Memorandum to the City of Markham Committee of Adjustment

File: A/016/25
Address: 8330 Woodbine Avenue, Markham
Agent: API Development Consultants Inc. (Natalia Garavito)
Hearing Date: Wednesday, April 2, 2025

The applicant is proposing to construct a branded Hotel 'HOME 2 & TRU ' by Hilton. The proposed development includes a new 14-storey hotel with 192 Rooms, 3 floors of amenities including the basement and 12 floors of rooms. The applicant is currently retaining the existing motel fronting on Lanark Drive, and is expected to be re-branded as “Spark by Hilton”. A total of 222 parking spaces will be provided as part of the proposal for the existing and proposed hotel uses.

MINOR VARIANCE SITE PLAN

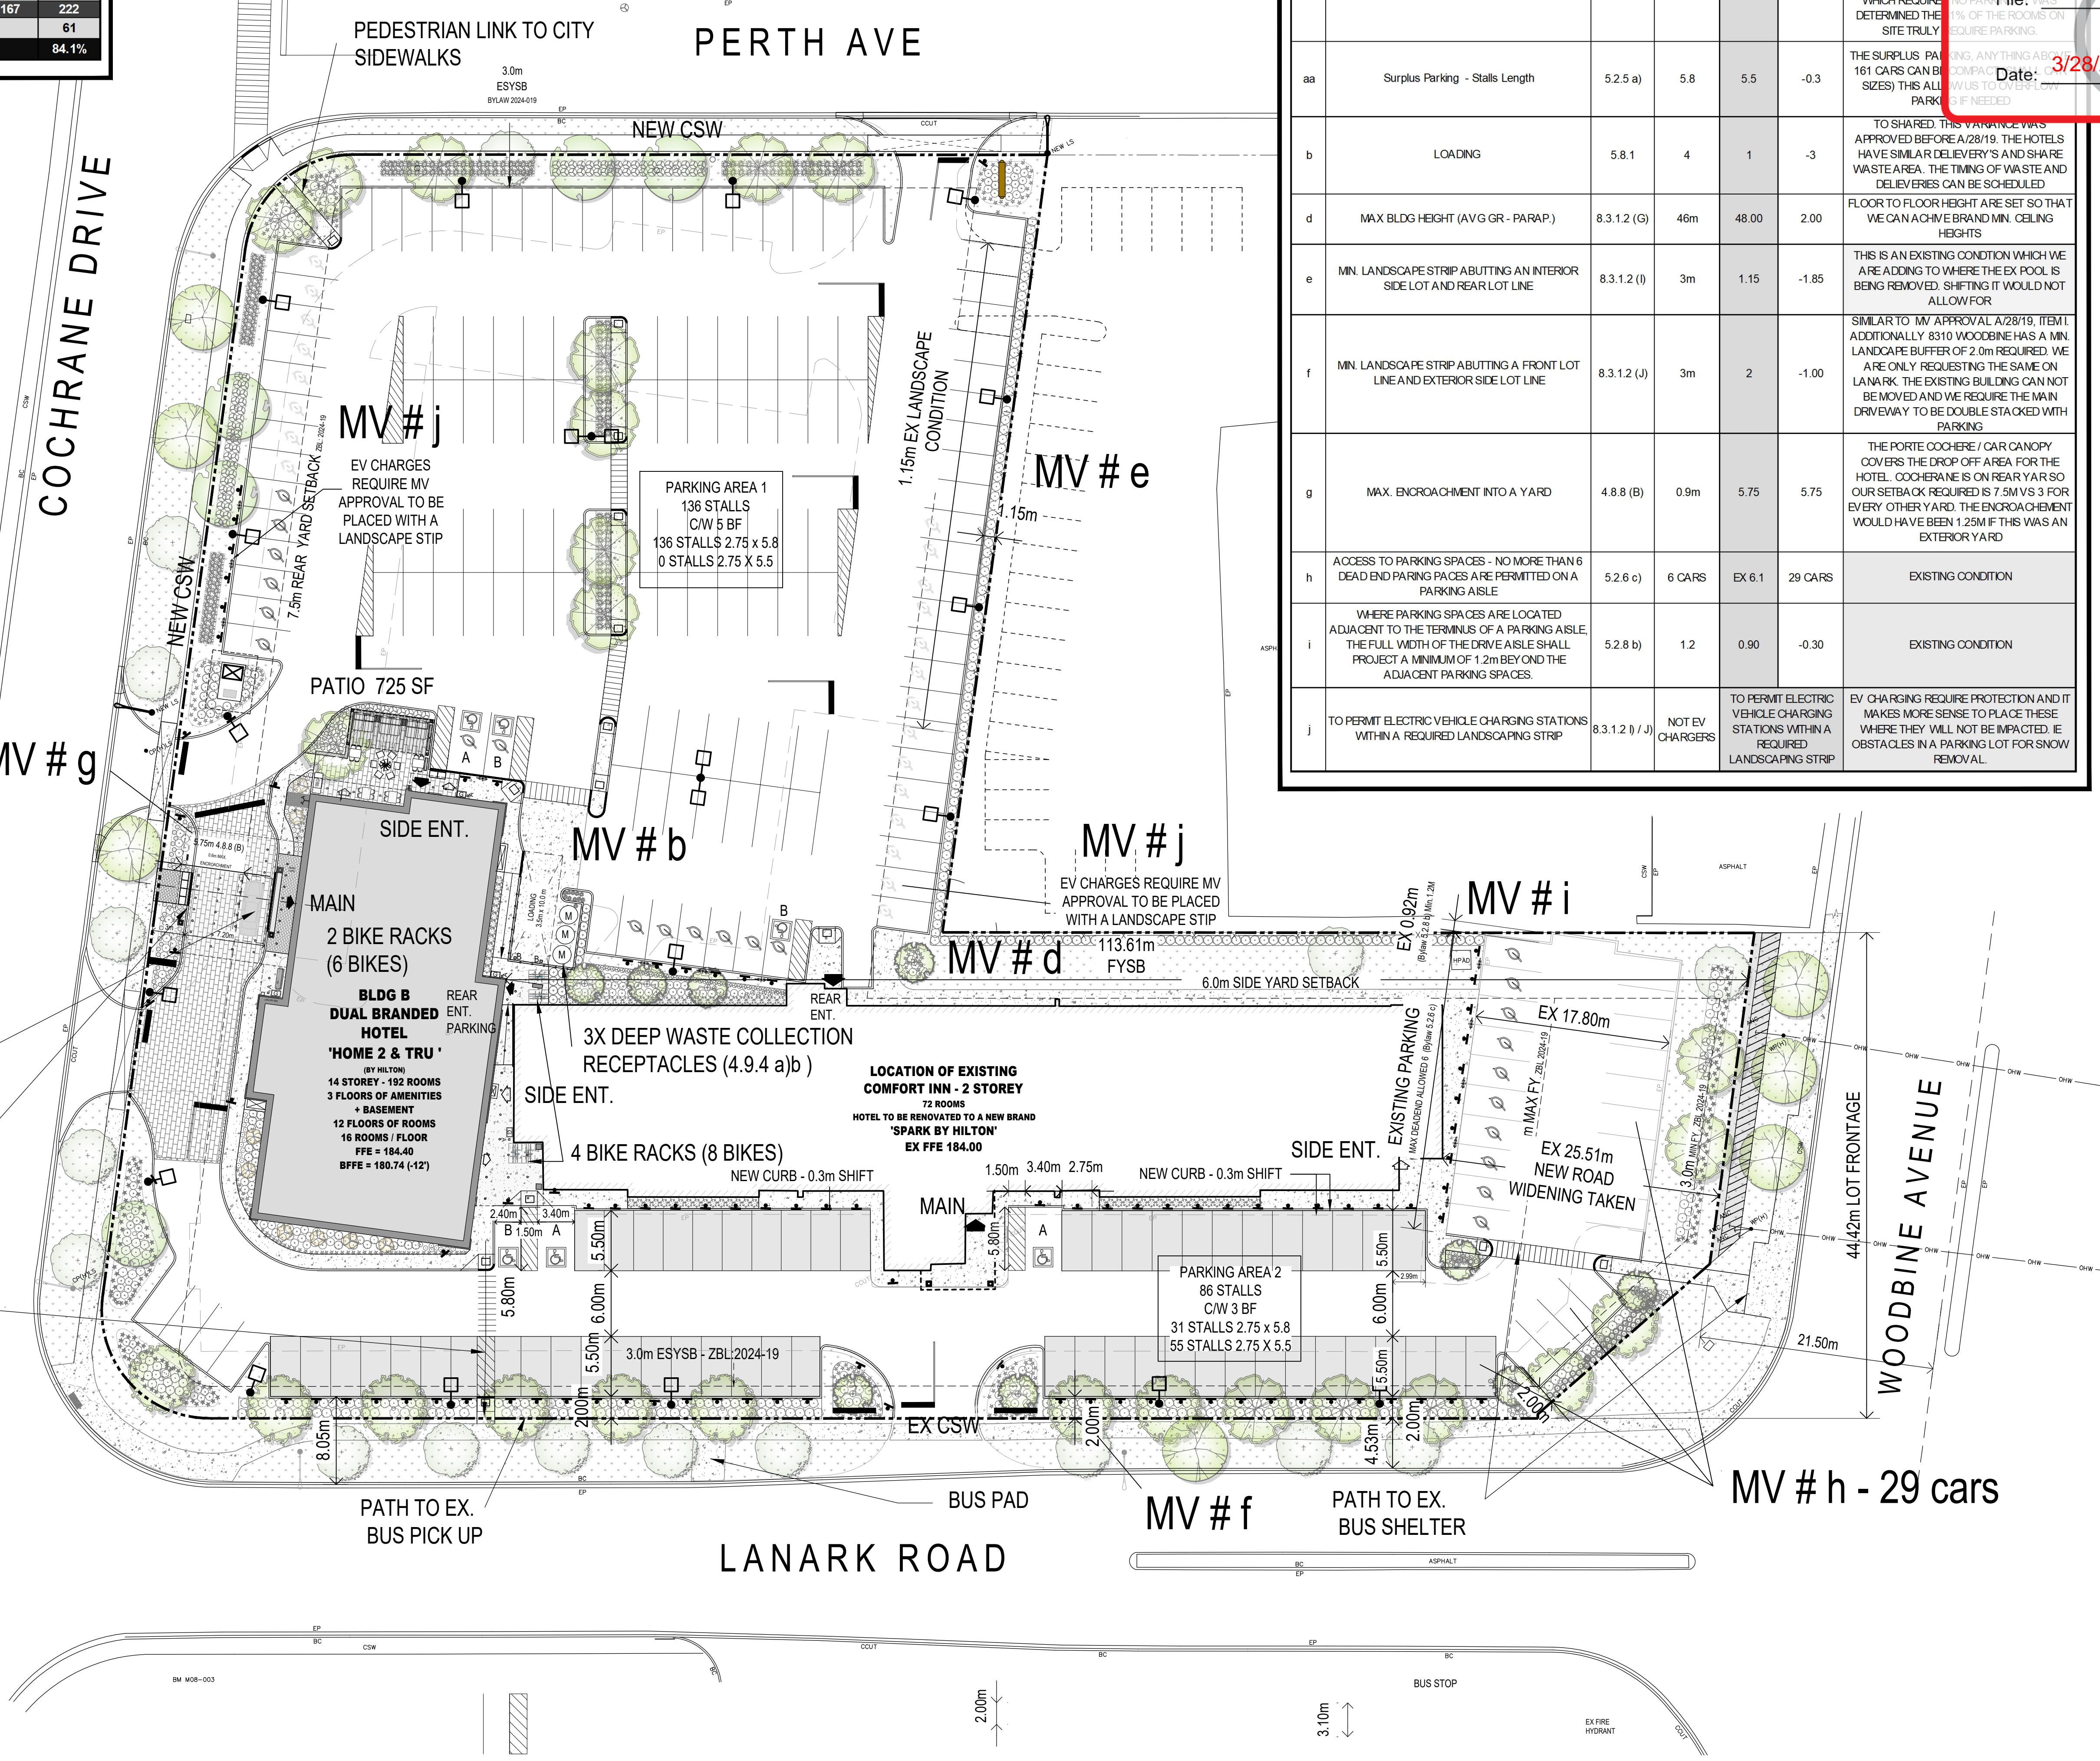
The Applicant is requesting to permit 61 parking spaces with a reduced parking length of 5.5 m, whereas the by-law requires a minimum length of 5.8 m.

Staff note that the Hotel is within a Major Transit Station Area (MTSA), which exempts the “Subject Property” from minimum parking space requirements in the By-law. However, the Applicant submitted a Parking Study to determine the required parking supply for the hotel. The study concluded that 222 spaces, with 61 of those spaces deemed as “surplus”, will be required for the site. As the Applicant has provided additional parking spaces for the proposal, a variance is still required as any number of parking spaces provided for the Subject Property need to meet the required parking space measurements.

The 5.5 m dimension will allow for a 6 m wide drive aisle needed for the southern access point at Lanark Drive with the existing Comfort Inn. Additionally, Transportation Staff have advised that the reduced parking space lengths will be clearly marked with signage indicating that it is a “small parking space”. As such, Staff has no objection to the parking space variance, as it maintains an appropriate parking supply within on-site circulation.

The Applicant is requesting relief to permit a minimum landscaping strip abutting an interior side lot line or rear lot line (along Cochrane Drive) of 1.15 m, whereas the By-law requires a minimum landscaping strip of 3 m. The Applicant is also seeking relief from the By-law to permit a minimum landscaping strip abutting a front lot line (along Woodbine Avenue) or exterior side lot line (along Lanark Drive) of 2 m, whereas the by-law requires a minimum landscaping strip of 3 m.

The variances reflect existing conditions on the subject lands. The reduced 1.15 m landscape strip located on the east side of the property will result in the removal of the existing pool to implement parking for the proposed hotel. The reduced 2 m landscape strip located on the south side of the property will allow for surplus parking to be provided along the Lanark Drive frontage. Providing a compliant landscape strip cannot be achieved due to the existing building and frontage on site. Staff is of the opinion that the requested variance is minor in nature and will not have any adverse effects to the site.

The Applicant is requesting to permit a roof canopy overhang encroachment of 5.75 m into the required rear yard setback, whereas the by-law permits a maximum encroachment of 0.9 m.

This variance is being requested to allow for the car canopy covering the drop off area located at the main entrance of the proposed hotel, facing Cochrane Drive. Staff has no concerns with the canopy and are of the opinion that the requested variance is minor in nature and appropriate for the main entrance of the hotel.

The Applicant is requesting to permit a maximum of 29 dead end parking spaces on a parking aisle, whereas the by-law permits a maximum of 6 dead end parking spaces on a parking aisle.

This variance is being requested to recognize the existing dead end at the eastern portion of the property, adjacent to Woodbine Avenue. The variance is required to meet the required parking supply established in the parking study, adding additional spaces to the parking aisle. Furthermore, the requested variance will maintain the required 6 m drive aisle access within the subject lands. As such, Staff has no concern with the variance as it is minor in nature and are incorporated appropriately within the subject property.

The Applicant is requesting to permit a minimum parking aisle projection beyond the adjacent parking spaces to the parking aisle terminus of 0.9 m, whereas the by-law requires the full width of the aisle to project 1.2 m beyond the adjacent parking spaces to the parking aisle terminus.

The variance is being requested to recognize an existing condition on the subject lands. The parking aisle is located next to the existing Comfort Inn, preventing any further compliance for the projection. Due to the constraints on site, and the required spaces determined by the parking study, Staff has no concern with the variance. The relief is minor in nature and creates an appropriate parking layout.

The Applicant is requesting to permit electric vehicle charging stations to be located within the required landscaping strip, whereas the By-law does not permit electric vehicle charging stations within a landscaping strip.

The Applicant provided justification that lighting standards are already permitted in landscaping strips and serves as a logical location for electric vehicle charging infrastructure that can be integrated without consuming valuable parking spaces

or obstructing pedestrian pathways. For the purposes of snow removal, providing the electric vehicle stations within landscaping strips will also allow for the parking lot to be cleared without potential damages to the stations. Based on information provided by the Applicant, the proposed electric vehicle stations will be compact, low-profile, and will emit minimal heat, ensuring there will be no adverse effects on surrounding vegetation. As such, Staff has no concern with the variances as they are minor in nature and are appropriate for the proposed parking layout.

3. That the number of parking spaces with a length of 5.5 m shall not exceed 61 spaces and that a minimum of 55 parking spaces with a length of 5.5m shall be located to the south and east of the existing building.

4. That the number of dead end parking spaces on a parking aisle shall not exceed 29 spaces, located to the east of the existing building, and that a vehicular trace of vehicle turnings be provided to demonstrate that the spaces can function, to the satisfaction of the Director of Engineering or designate.
